SUBJECT: **NEW VEHICLE DEMONSTRATION / DELIVERY HOLD - Safety Recall 16S18 - Supplement #3**
Certain 2014-2015 Model Year Explorer and Police Interceptor Utility Vehicles
Rear Suspension Toe Link Replacement

Parts Requirements / Ordering Information: Has been updated to determine part requirements based on engine and AWD/FWD vehicle configuration. No action is required for vehicles previously repaired on or before March 13, 2019.

FIGURE 1

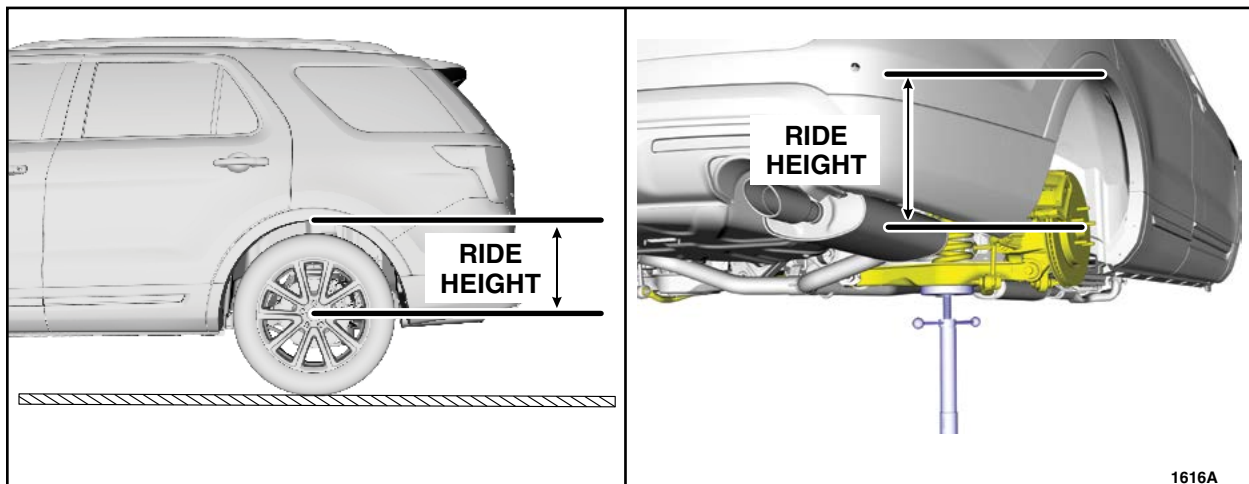
NOTE: The toe links must be secured at ride height during replacement. See Figure 1.
